UNITED STATES PATENT AND TRADEMARK OFFICE

APPLICATION NO.	FILING DATE	FIRST NAMED INVENTOR	ATTORNEY DOCKET NO.	CONFIRMATION NO.
10/531,838	04/18/2005	Thomas Aue	SCH-15950	4317

Office Action Summary

DETAILED ACTION

REPLACEMENT SHEET

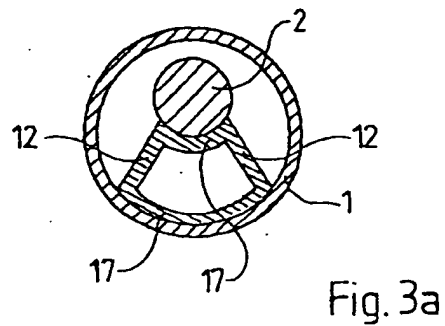
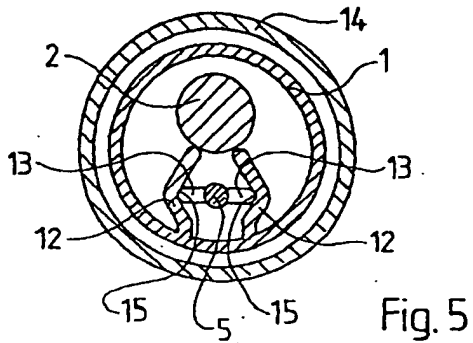
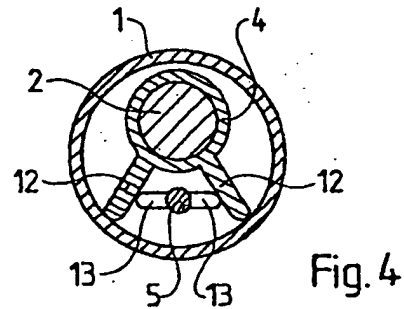
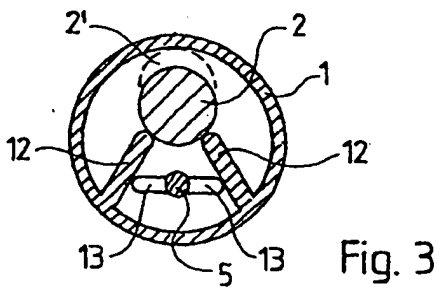
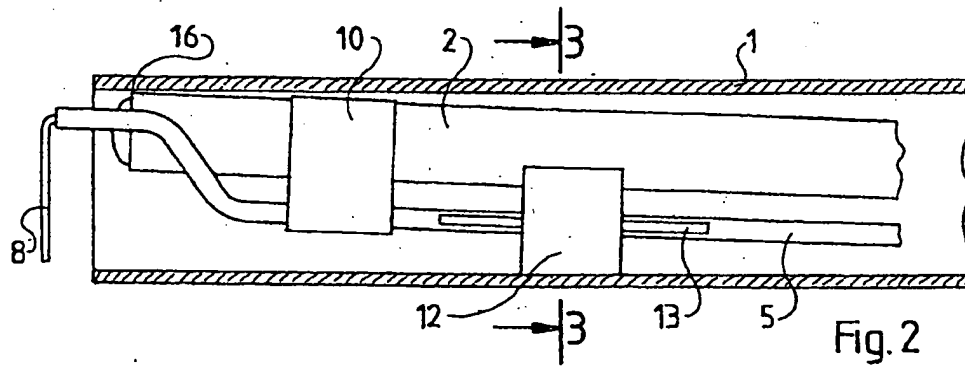
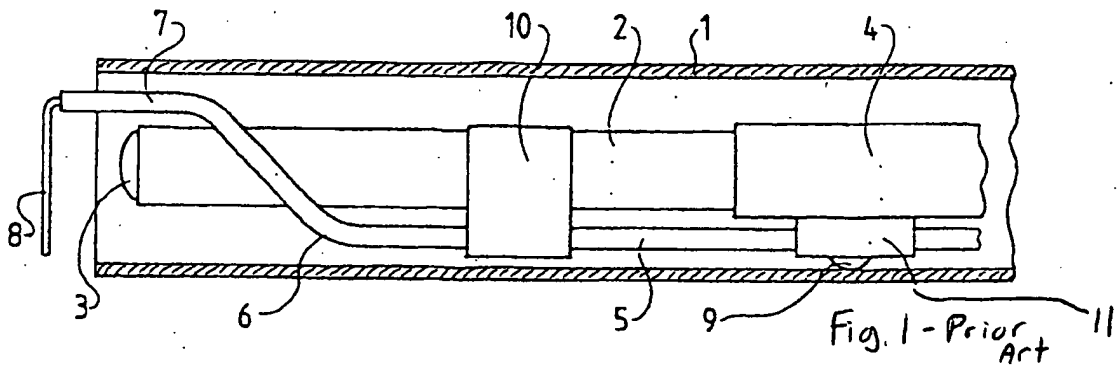
13. The replacement drawing sheet which includes "prior art" added to fig.1, was received on November 5th, 2007 and has been entered.

Accepted by examiner. 12/11/07
K. H. H. S.
